Remarks Supporting Amendment

“Drawings” Examiners Page 2
(Examiner’s Numbering Retained)

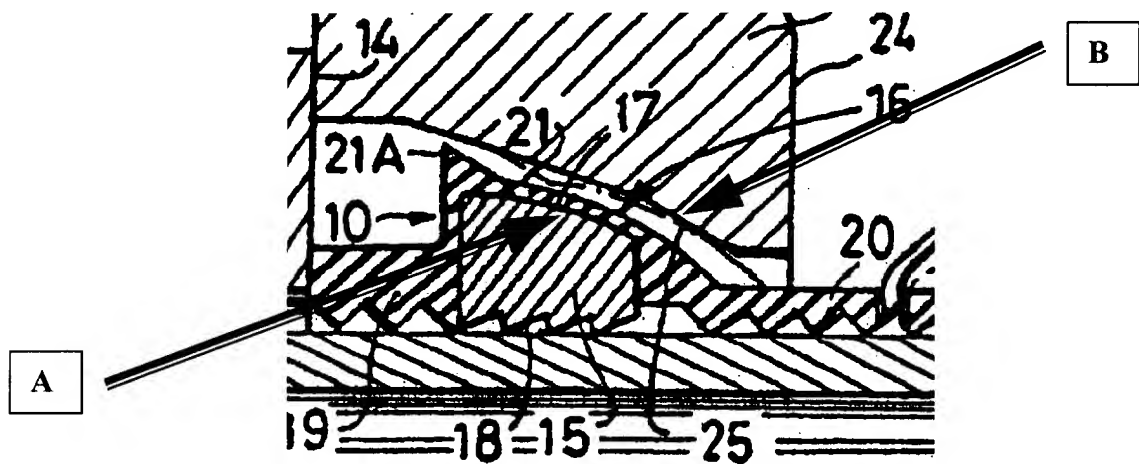
Amendments have been made to Claim 2 to place it in independent form; no new matter is believed to have been added. Under the standard recited from MPEP 2131, the burden is on the Examiner to show that the reference cited as anticipating prior art contains each and every element and limitation of the claims. Claim 2, as originally filed and as amended, recites that Applicant's "...locking member is adapted to pivot in response to a force tending to separate the first pipe portion from the second pipe portion...". Figure 1 of Percebois does not show any pivoting action or capability. In fact, the description in

Percebois would not be interpreted by any person of ordinary skill in the art to include suggest, or even allow, any pivoting action whatsoever.

Reference to Figure 1 of Percebois, as cited by the Examiner, is instructive; Applicant reproduces a close-up of the relationship between the locking segment (Percebois 15, Applicant 1) as shown in Percebois Figure 1 below, with additional reference lines for clarity of discussion:

Reference line B points to the inside curved surface of Percebois' counterflange 11. Reference line A points to the outer convex face 17 of Percebois' locking member (referred to as an "insert 15" by Percebois). As can be seen from the above image, upon extractive movement of the male end from the female end (e.g., movement of the inserted pipe toward the right), Percebois' locking member will also move right until A contacts B. It is evident that the convex shape of A is complimentary to the concave shape of B, meaning that A and B will mate. No opportunity is provided for pivoting of the locking member.

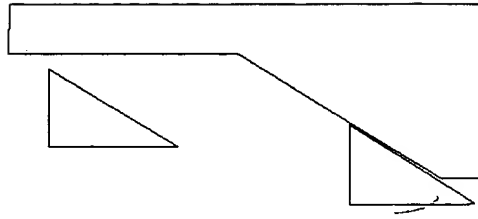
Notably, those in the art will understand that Percebois is depicting a known locking mechanism for push-on joints is the "sliding wedge." In a sliding wedge configuration, the locking segment is configured with a surface that slidably mates with a longitudinally resistive surface, as shown below:

In the above image, as the triangle, shown first as positioned to the far left, moves to the right, its slanted face will mate with the conversely slanted face of the large polygon. Once such face to face contact is made, the triangle will not pivot, but will be urged downward for every unit of movement made toward the right. This type of sliding wedge movement is commonly known in the pipes and appurtenances industry. Because of this industry background, persons reasonably skilled in the art would interpret Percebois' Figure 1 as involving just such a mechanism. This understanding is demonstrated correct by Percebois' discussion of the "backward" movement of the insert at Column 3, lines 50 – 66 and Column 4, lines 23 - 34.

Claim 13-15 – Percebois does not show a gasket and segment adapted to fit within the female end of a pipe.

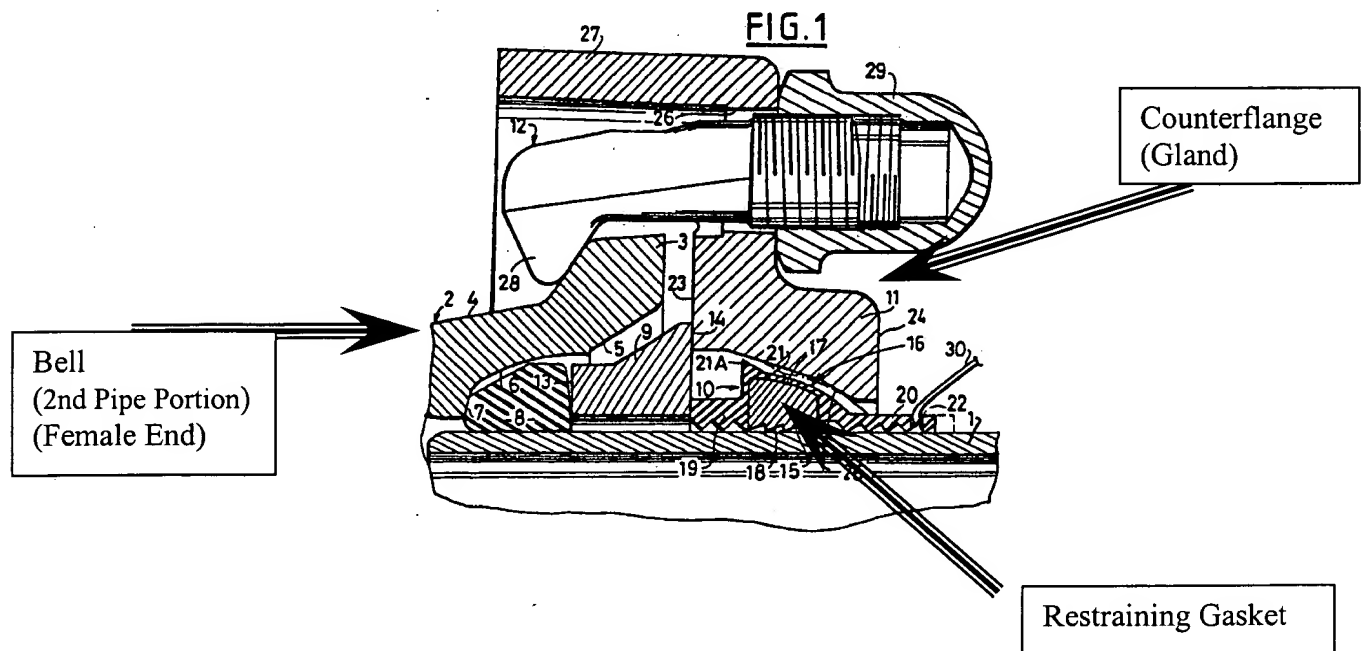
Claim 13 recites that the restraining gasket, along with its embedded locking segment, is “adapted to fit within a bell end of a second pipe length.” (e.g., the segment is in the bell of the female end) The Examiner’s assertion that Percebois demonstrates a gasket “adapted to fit within a bell end of a second pipe length 2,” (Office Action at p.7, line 9) is not in accord with Figure 1 of Percebois, upon which the Examiner relies. Figure 1 is reproduced below for clarity. Percebois defines pipe length 2 as the female end, or bell, of the juncture. See, Percebois 2:24-25. Percebois’s item 11 is a counter-flange, and not part of the bell at all. See Percebois, at Abstract and 3:10-30. As is evident by viewing the reproduction of Figure 1 below, the retaining gasket of Percebois fits within the counterflange (termed “gland” by Applicant); it does not assemble within Percebois’ bell end 2.

Percebois thus does not show the same arrangement of elements as recited in the claim. Percebois therefore fails the requirement of MPEP 2131 that the "elements must be arranged as required by the claim... In re Bond...." The rejection accordingly fails to set forth a defensible prima facie case of unpatentability, and must be withdrawn.
